LOT 9 PARKER POINTE

LOT 10, PARKER POINTE FILING NO. 1

COVER SHEET

SITE PLAN

SITE PHOTOMETRIC PLAN

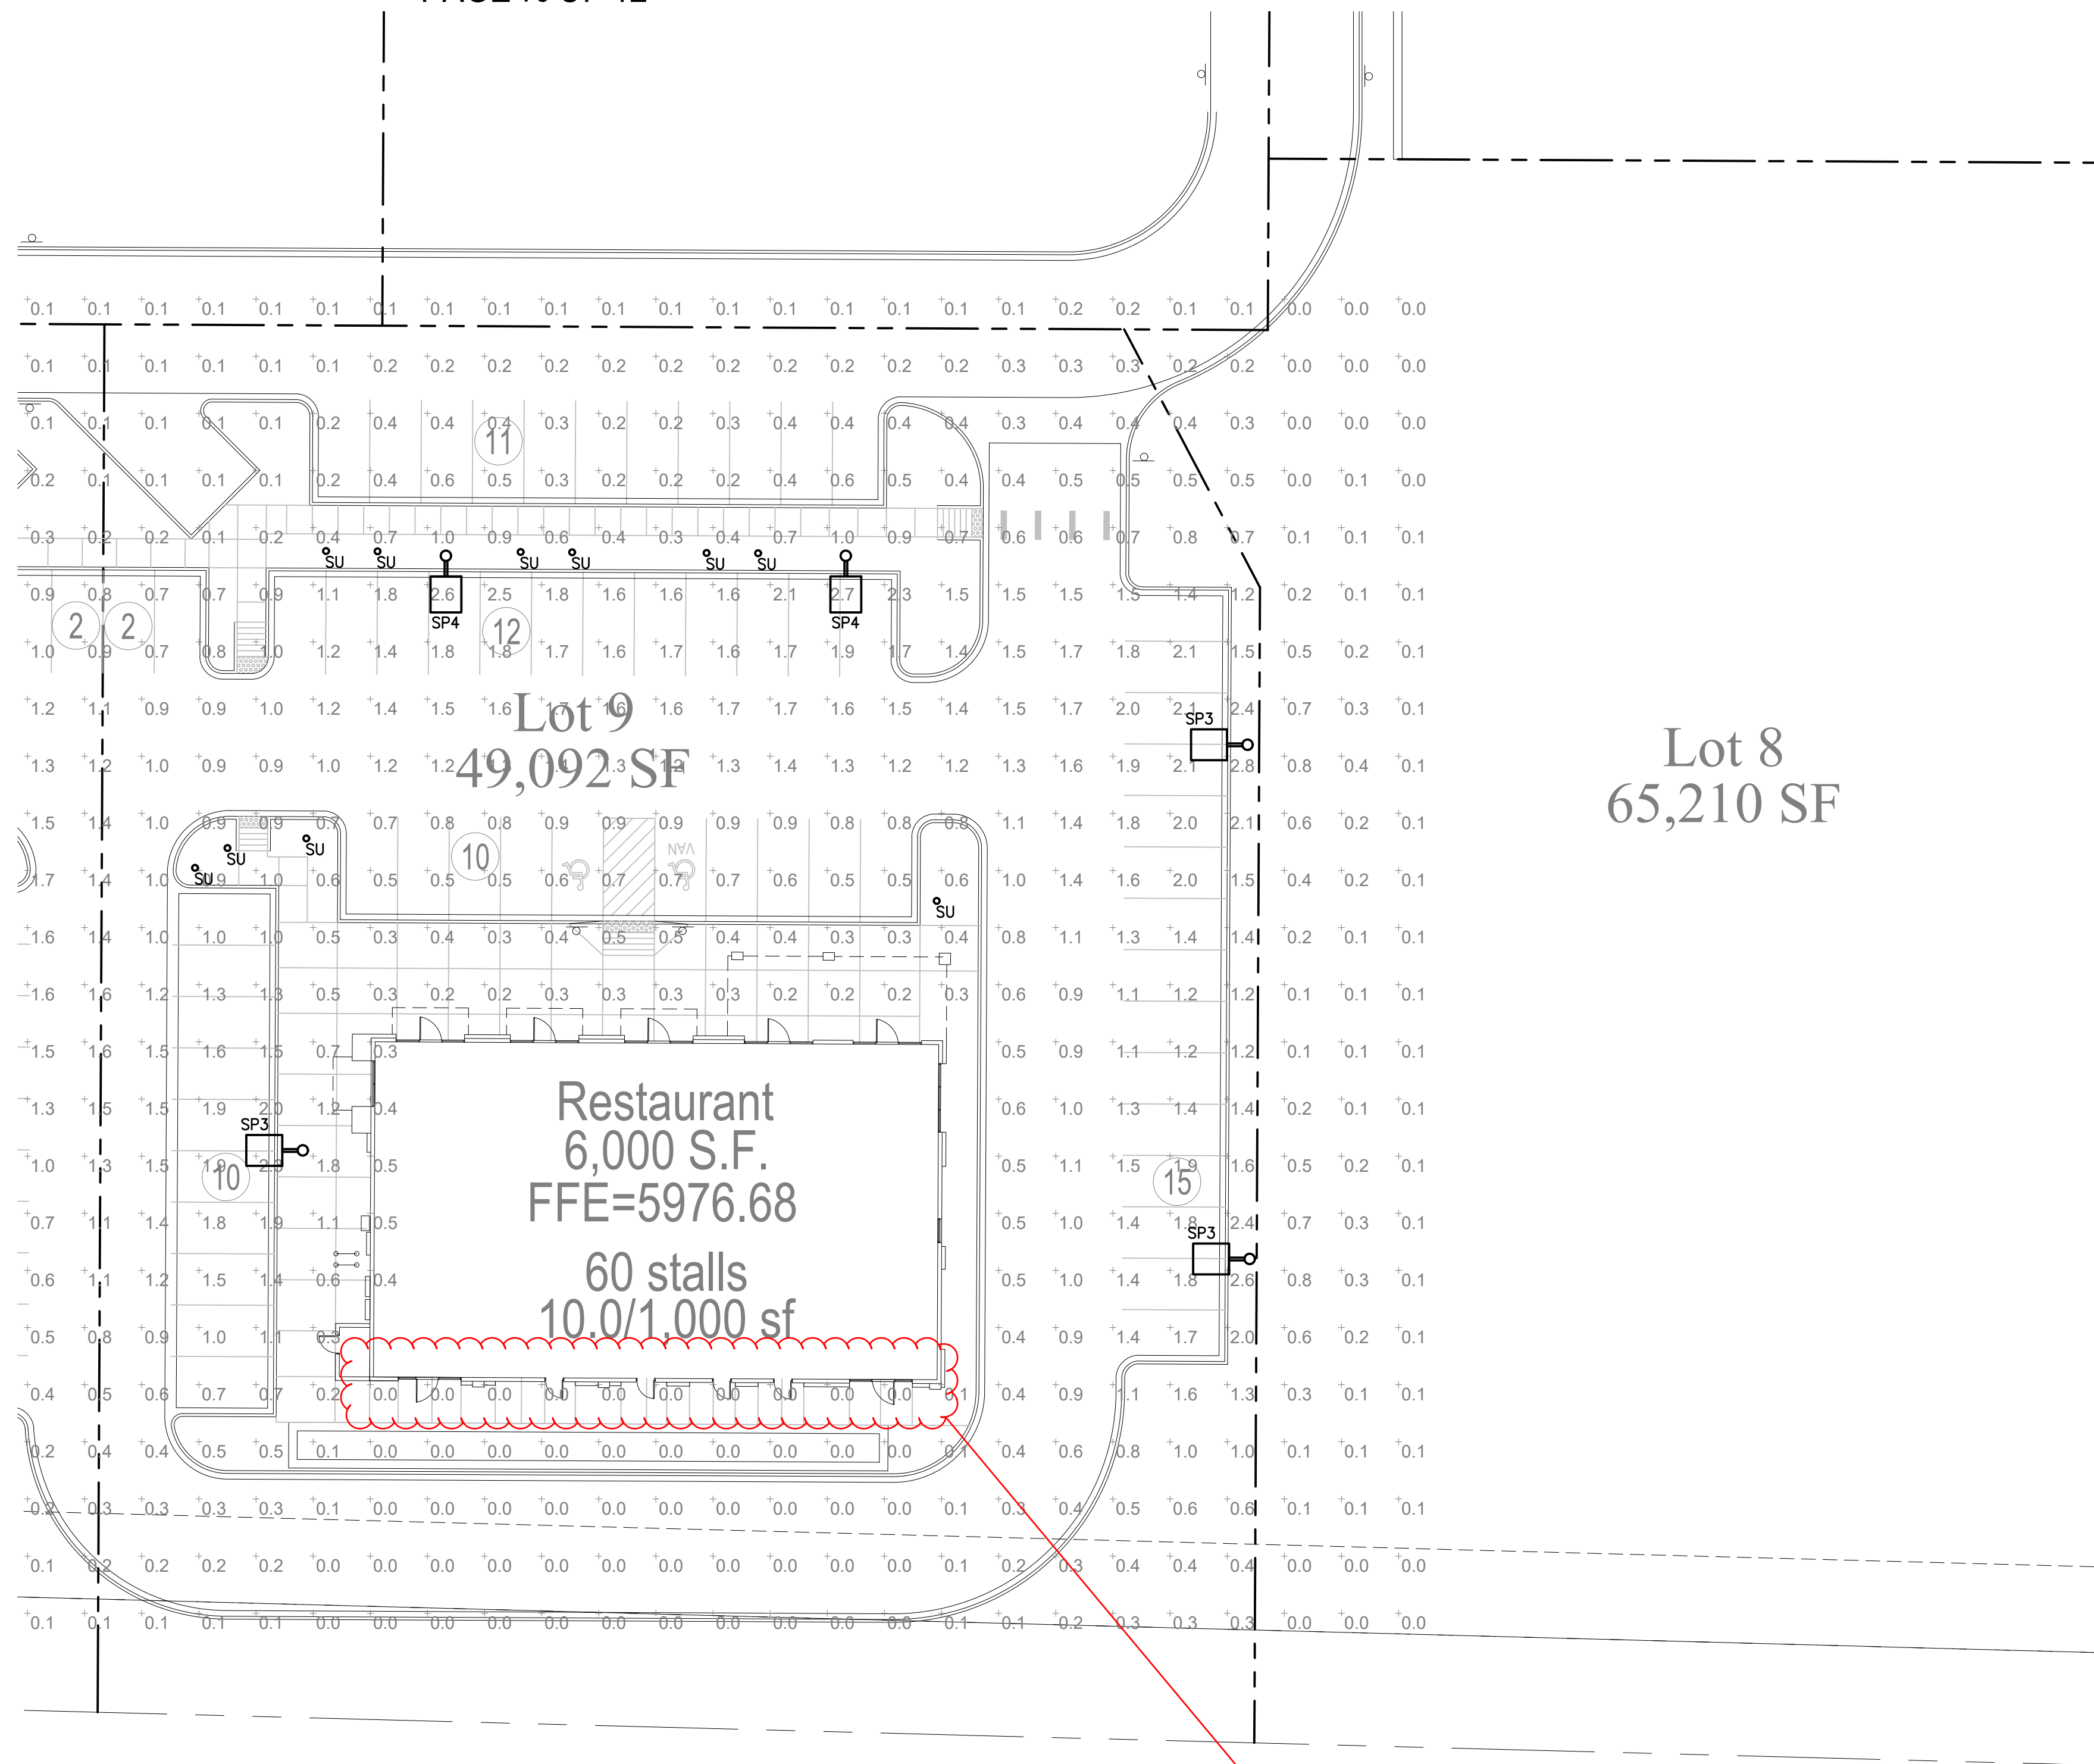
Must use positive number, please recalculate.

Decorative wall lighting has not been shown and no cut sheet has been provided.

There are access doors on this elevation. Additional lighting is needed. Additional lighting has been suggested on the mock up on 9 of 12 though another idea that would meet the intent would be considered.

SITE LIGHTING DETAILS

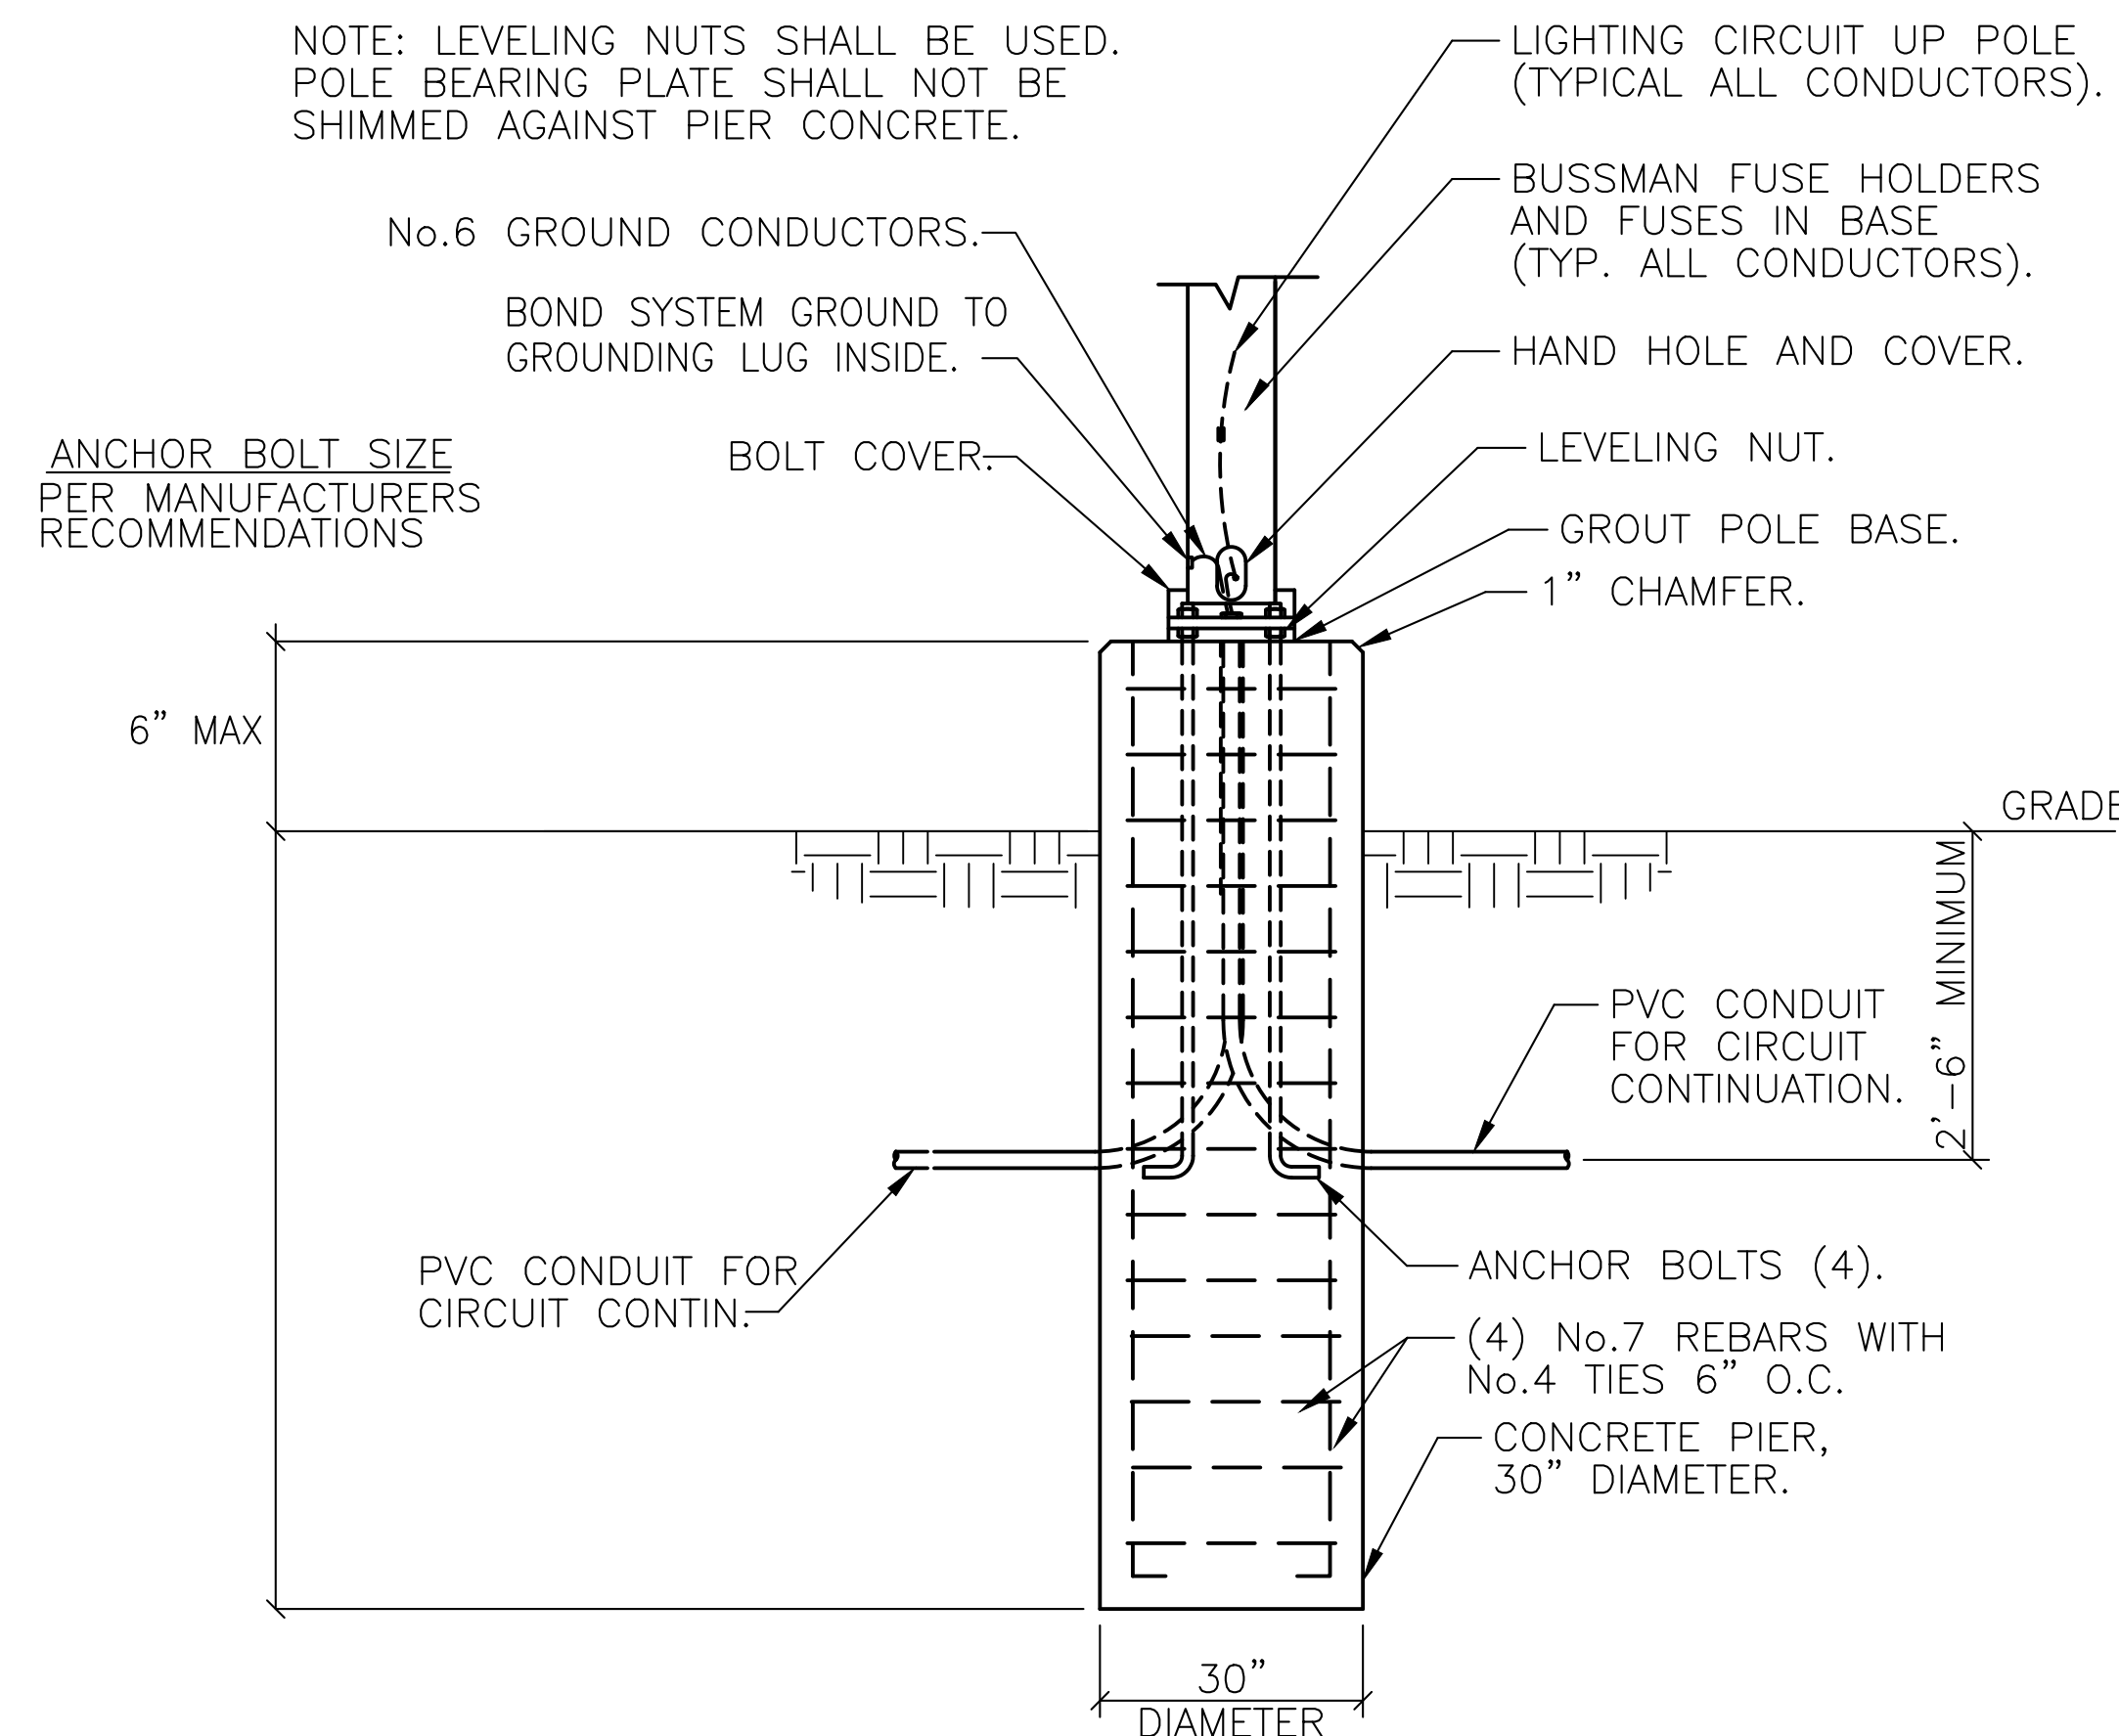
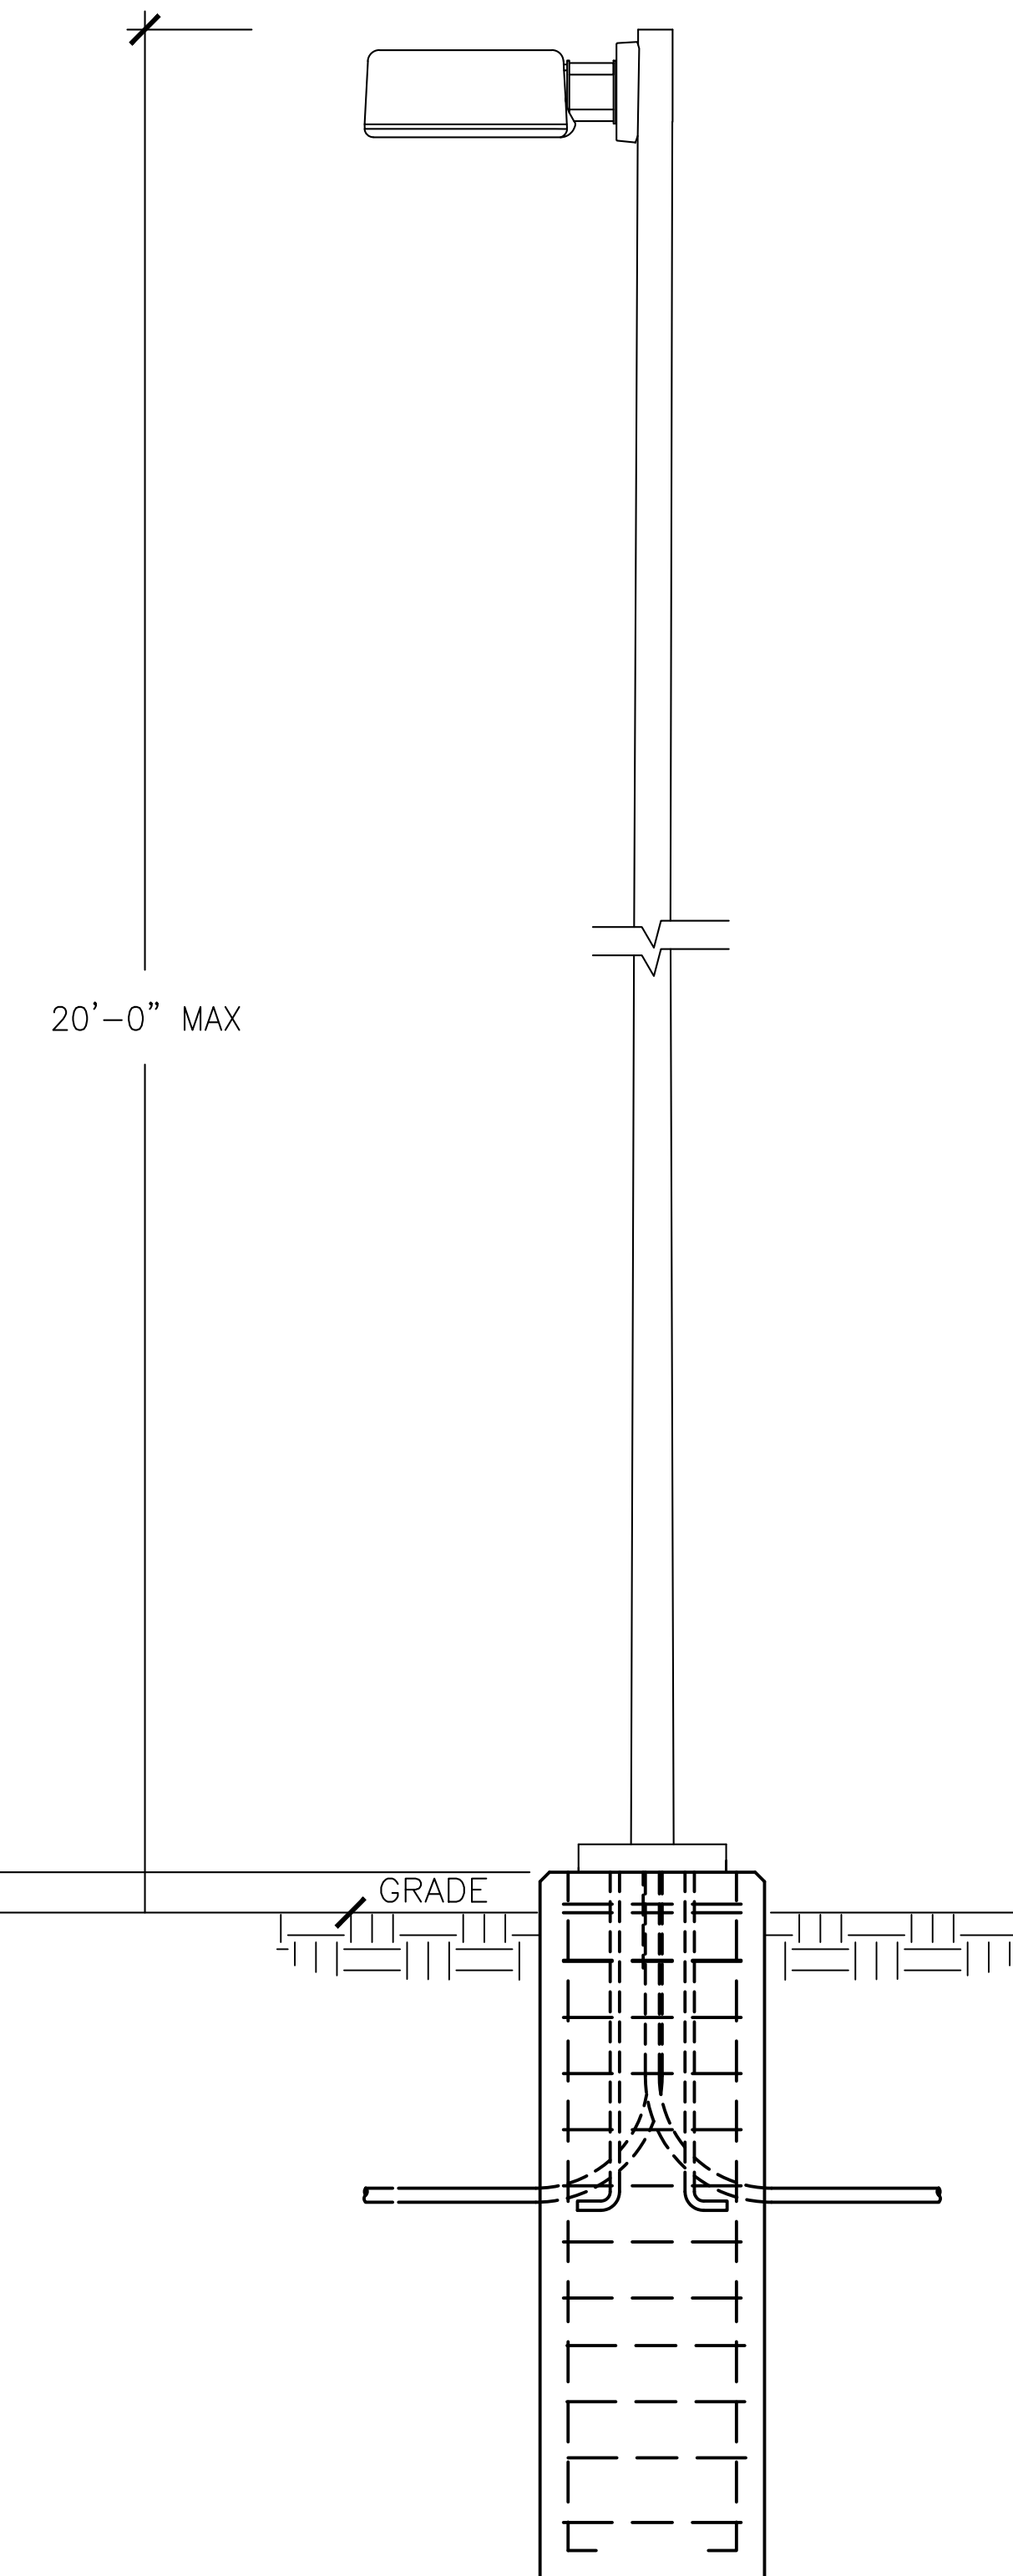
Missing fixtures and no quantities provided.
